INDESIT company

Model type:
WITL86EU

Commercial code:
F034263

n1040345: Replacement of drum lock button TL EVOII.

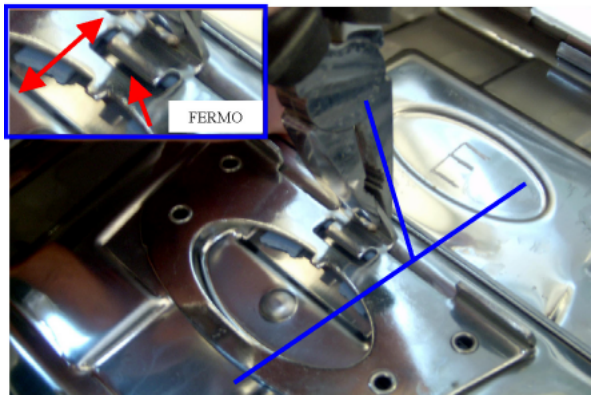
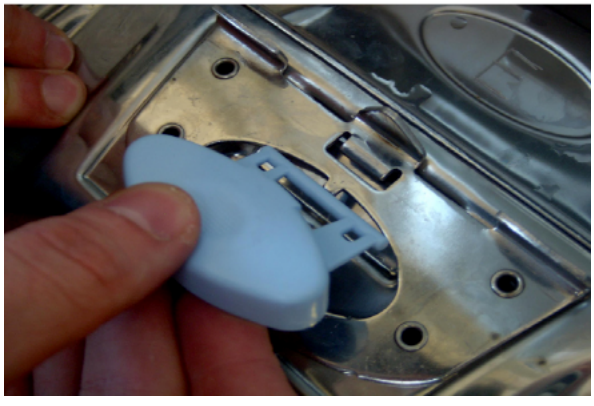
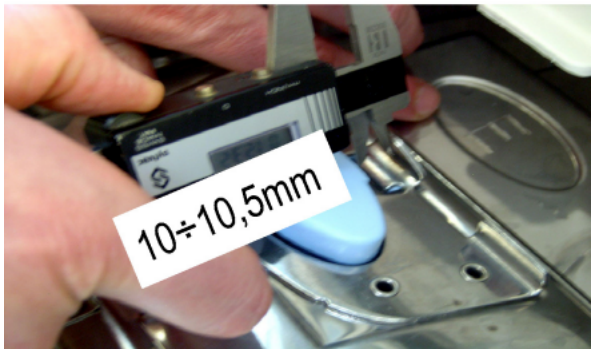
Tools and material needed: pliers, screwdriver, gauge, spring P/N Sat 114989, button P/N Sat 114990.

1) turn the central tip of the catch in the direction shown (FIG.1);

2) bring the tip to a vertical position and ensure that the broken button is disengaged from the catch restraint and can be removed (FIG.2);

3) remove the remaining part of the button with the aid of a screwdriver, taking care not to scratch the doors (FIG.3);

4) pre-assemble spring to button (FIG.4);

5) insert button between catch and door (FIG.5);

6) bring the button into position and arrange the spring in its location in the door (FIG.6);

7) turn the central tip of the catch in the direction shown to return it to its starting position (FIG.7);

8) check the distance between button and catch (FIG.8);

9) check correct operation of the button when opening and closing the doors (slight inclination errors of the catch can result in faulty closing of the doors) (FIG.9).

n1040382: Drain pump with bayonet-style filter - top Loading Brembate

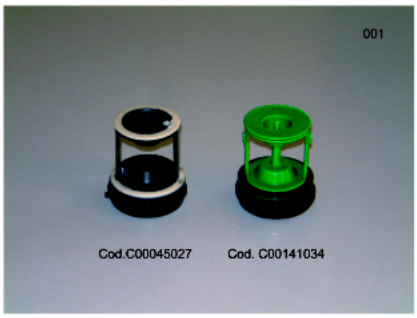
From serial no. 51021.0001 a new drain pump with bayonet-style filter has been installed on all top loading washing machines manufactured in Brembate.

New parts:
C00141862 - Drain pump
C00141034 - Pump filter kit

Premodification parts:
C00111409 - Drain pump
C00045027 - Pump filter kit

The new parts can be used instead of premodification ones.

N1040404FIG1

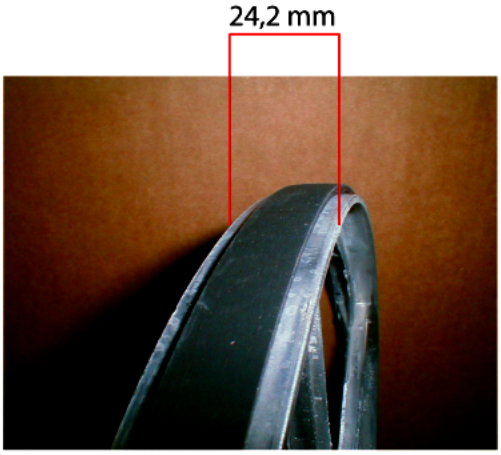
n1040404: New pulley installed on top loading washing machines up to 1000RPM (NO tub lock)

From serial no. 51202.0001 the pulley track has been widened from 21.2mm to 24.2mm (see picture N1040404FIG1).

new pulley
C00142832 - D280 24.2 mm track

Premodification pulley
C00083912 - D280 21.2 mm track

The new pulley can also be used on premodification versions of the models referred to in this release.
